Project Name: PPSD CTE Renovations
Project Number: 25-009

ADDENDUM NO. 1

5 PLAN DETAIL 1
3/4" = 1'-0"

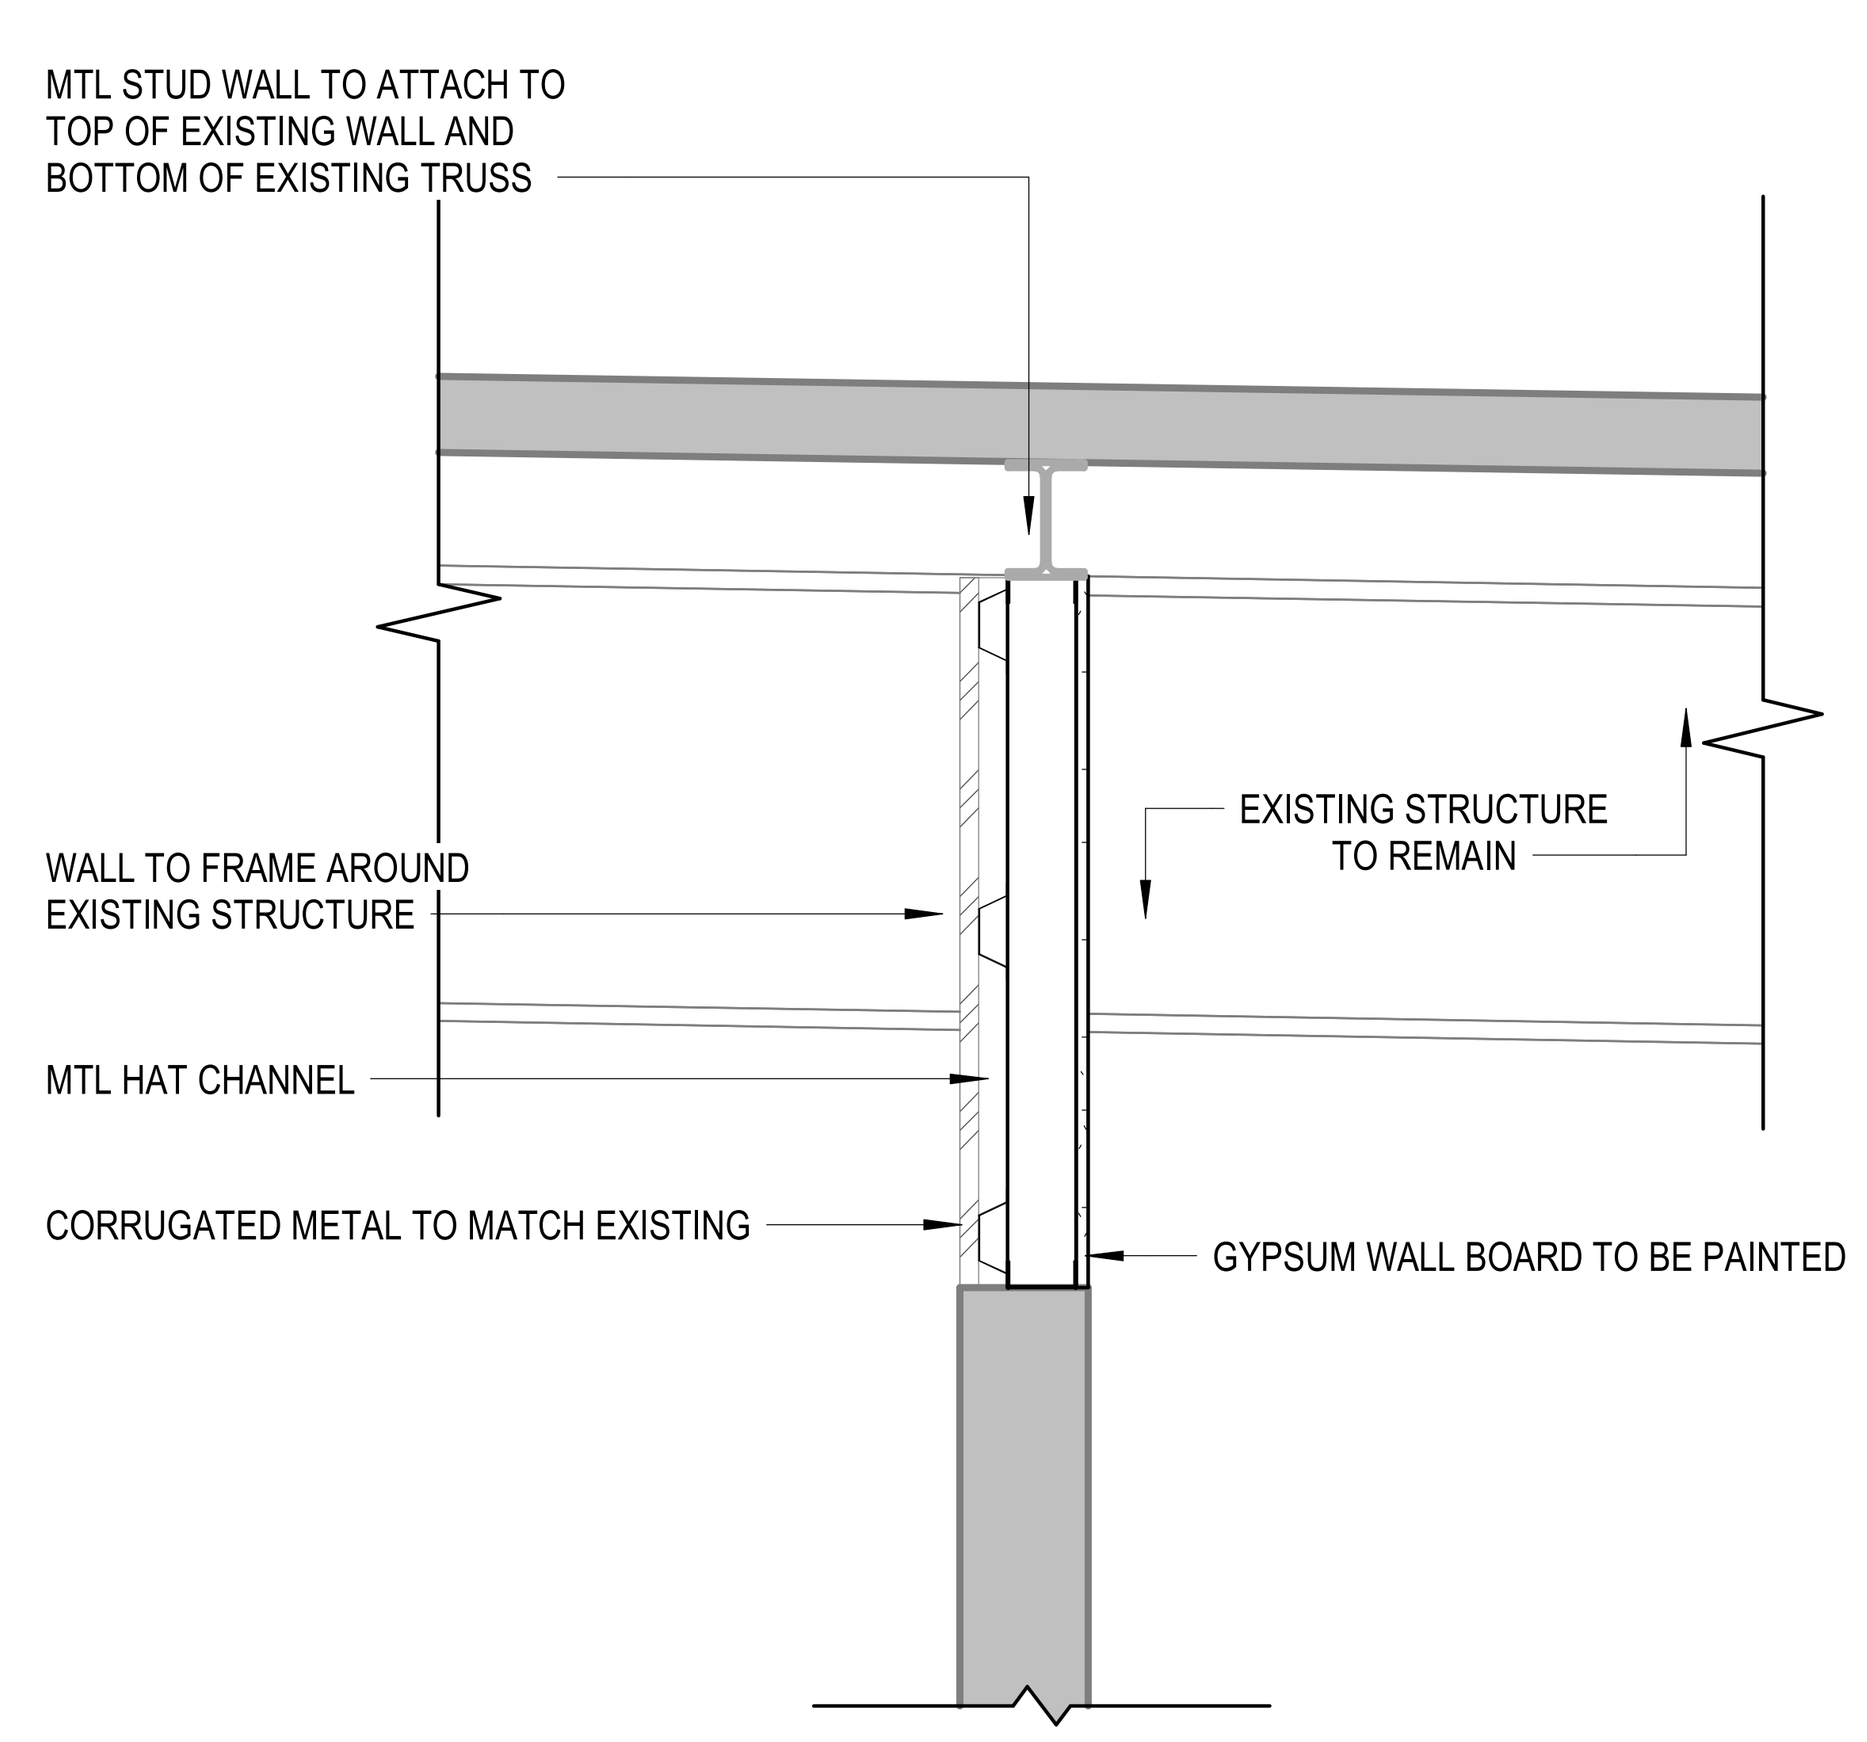
QUESTION 04 "Section 07.4213 - Metal Wall Panels - Can not find on the drawings where metal wall panels are utilized. Please clarify where this section applies to the project."

ANSWER 04 Refer to Detail 5/A101. At the mezzanine level, where the wall is being extended to the underside of the deck, a new corrugated metal panel will be installed to match the existing paneling within the space.

MECHANICAL PLAN

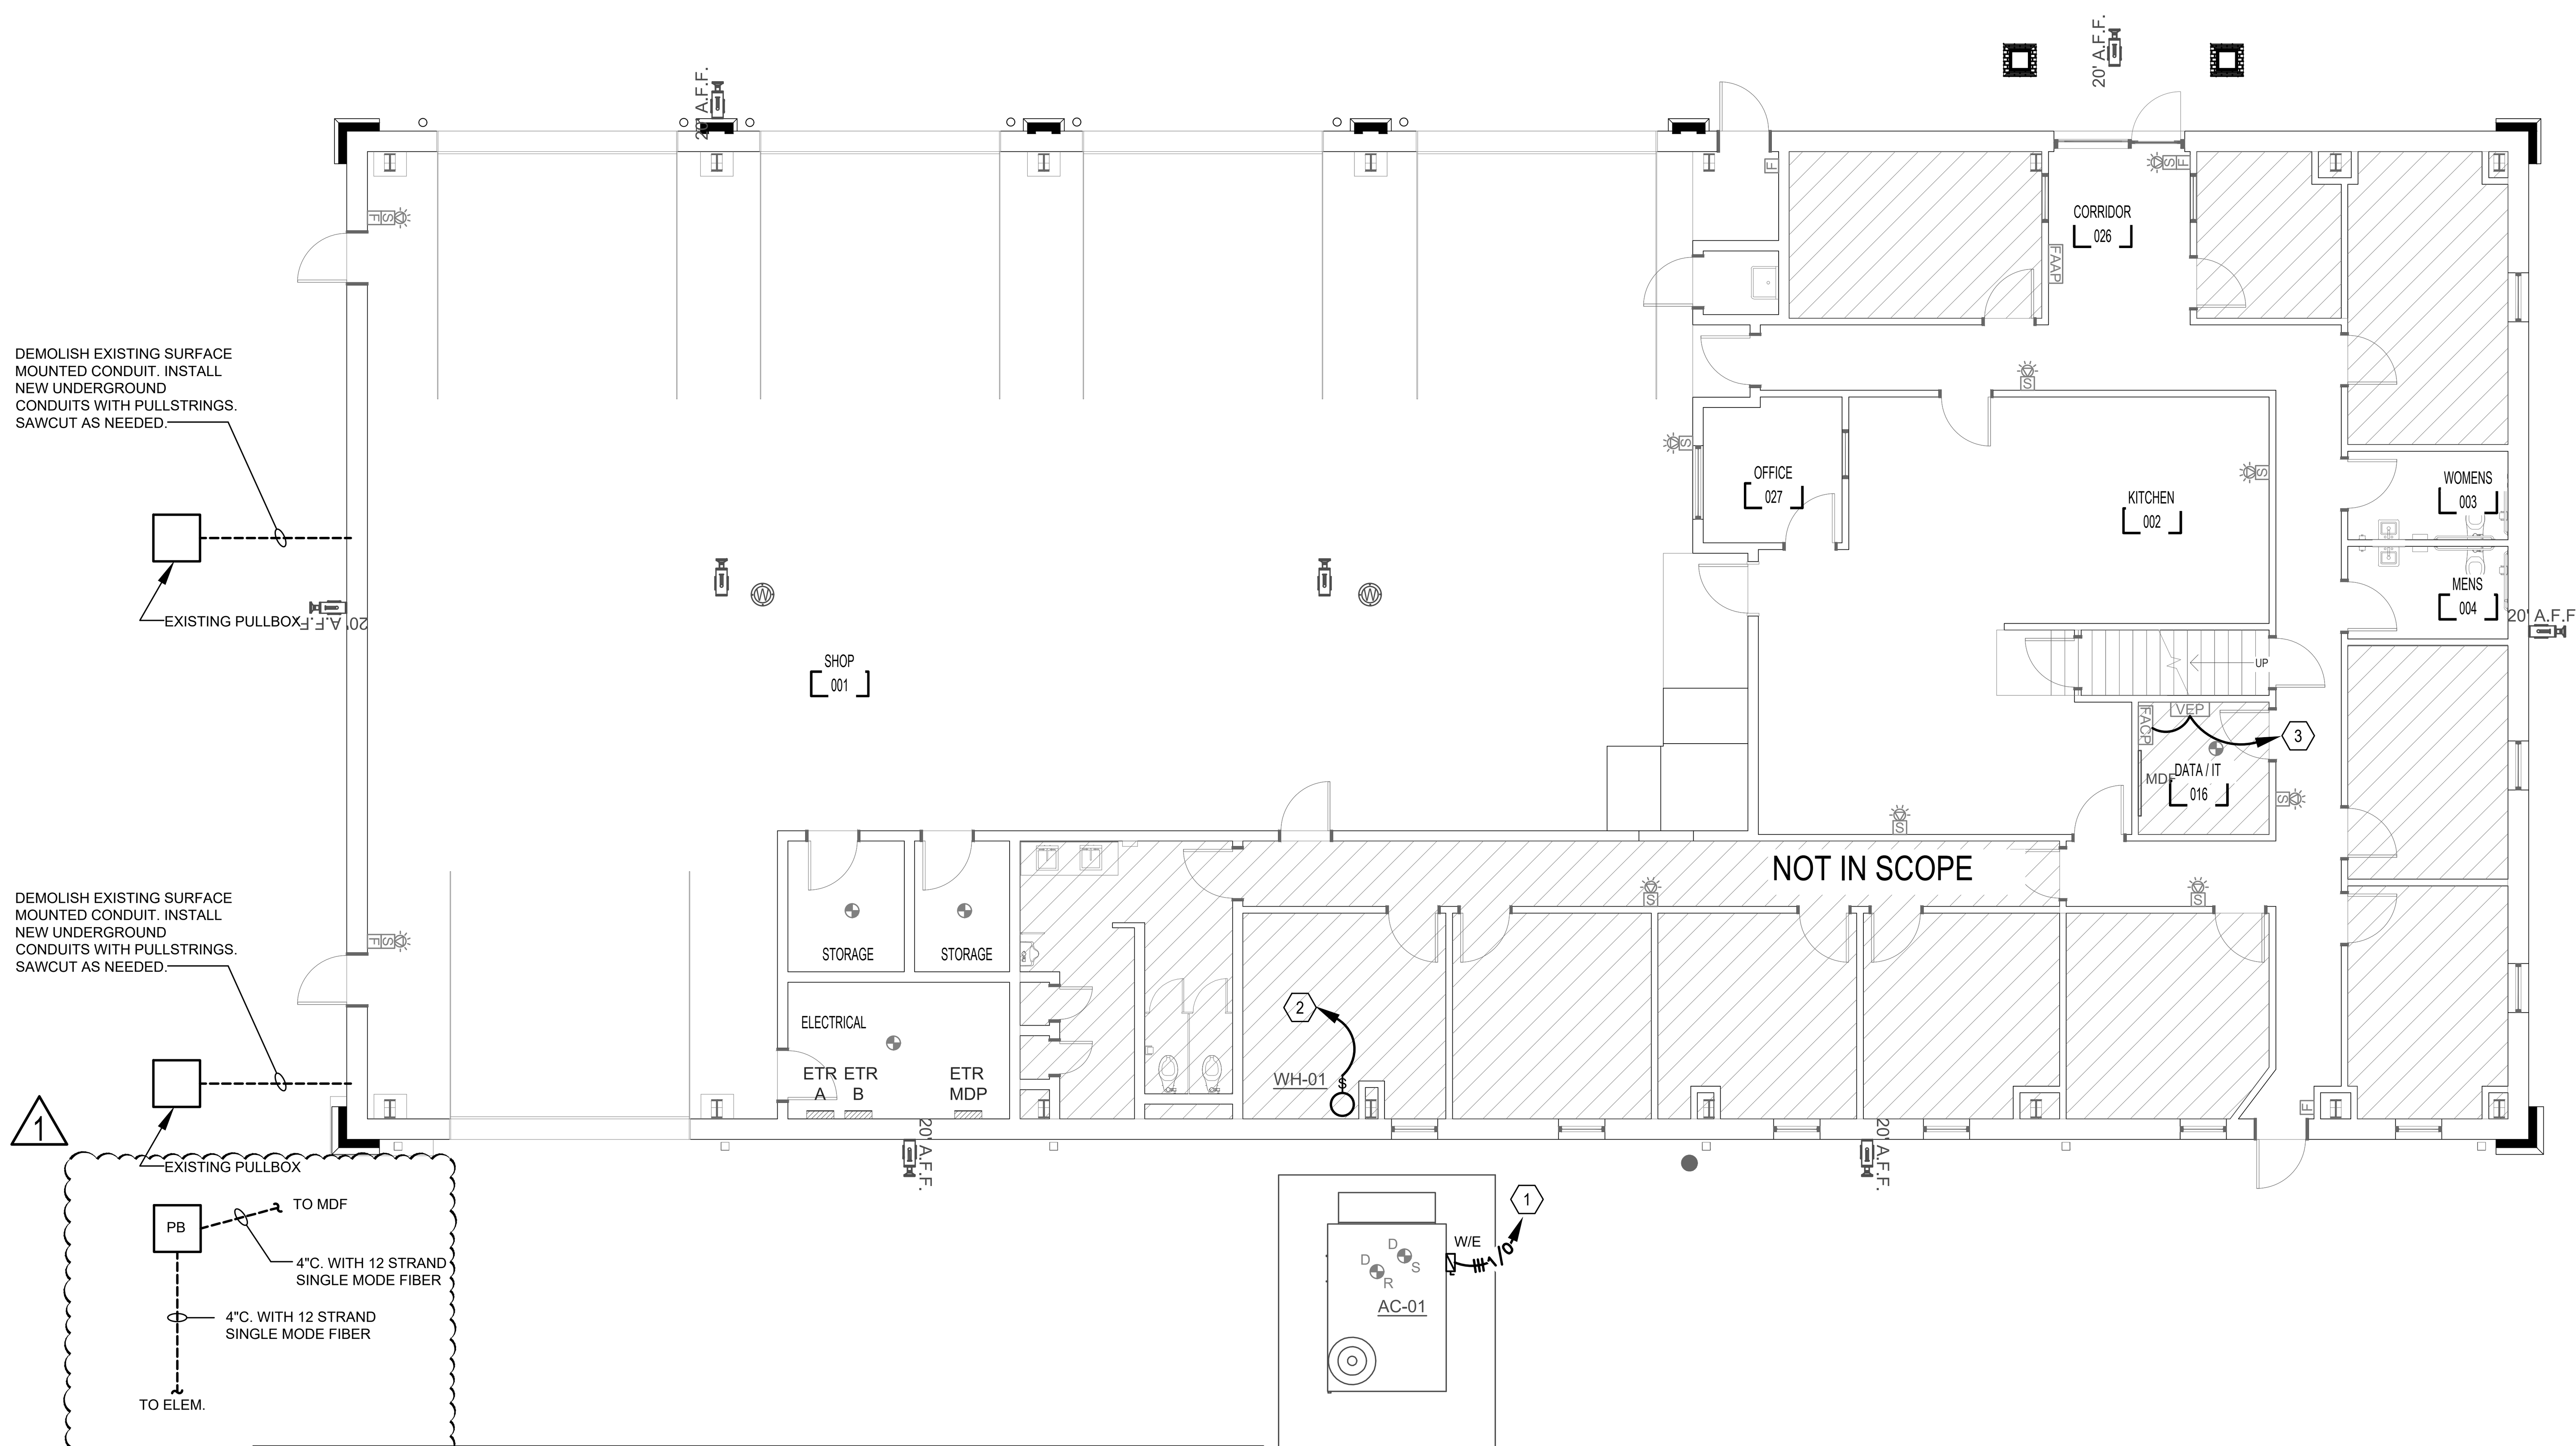
ITEM NO. 10 **Sheet E200 | MECHANICAL PLAN**
REPLACE sheet E200: Mechanical Plan
Clarification: Located new pullbox
